Access Compliance Report

Public Rights-of-Way

(Curb Ramps)

Intersection ID: 14501	Main Street: BALDWIN_AV	Cross Street: ELLISON_ST	Location: W
ADA ID: FD2385798F65	Ramp Type: PerpDiag	Initial Pass/Fail: Fail	Overall Compliance: No
		Severity Score: 25

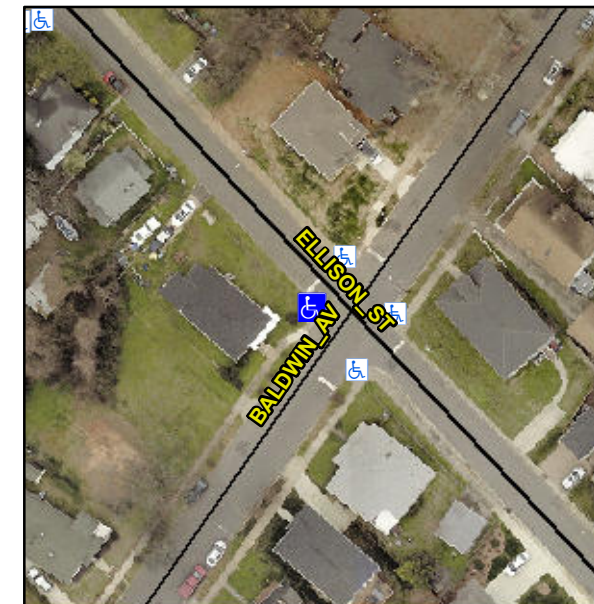
Not Found, R304.2.2

Compliance	Description	Data	Compliance	Description	Data
N/A	Ramp Length (in)	41.0	No	Ramp Slope (%)	14.6
Yes	Ramp Width (in)	48.0	Yes	Ramp XSlope (%)	0.5
N/A	Flare Type LT	N/A	N/A	Flare Type RT	N/A
N/A	Flare Slope LT (%)	N/A	N/A	Flare Slope RT (%)	N/A
N/A	Flare Traversable LT?	N/A	N/A	Flare Traversable RT?	N/A
N/A	Landing Length (in)	N/A	N/A	DWS Provided?	N/A
N/A	Landing Width (in)	N/A	N/A	DWS Contrast?	N/A
N/A	Landing Slope (%)	N/A	N/A	DWS Length (in)	N/A
N/A	Landing X Slope (%)	N/A	N/A	DWS Full Width?	N/A
N/A	Landing Curb? (Y/N)	N/A	N/A	DWS Offset (in)	N/A
N/A	Shared Landing?	N/A			
N/A	Gutter Ponding?	Yes	N/A	Gutter Slope (%)	N/A
N/A	Gutter Lip Ht (in)	N/A	N/A	Gutter X Slope (%)	N/A
N/A	Painted X Walk1?	No	N/A	Painted X Walk2?	No
	X Walk 1 Direction	To SE		X Walk 2 Direction	To NE
N/A	X Walk 1 Width (in)	N/A	N/A	X Walk 2 Width (in)	N/A
	X Walk 1 Slope (%)	1.1		X Walk 2 Slope (%)	3.0
	X Walk 1 X Slope (%)	3.2		X Walk 2 X Slope (%)	1.7

Remove & Replace Curb Ramp With Two New Directional Ramps or Equivalent.
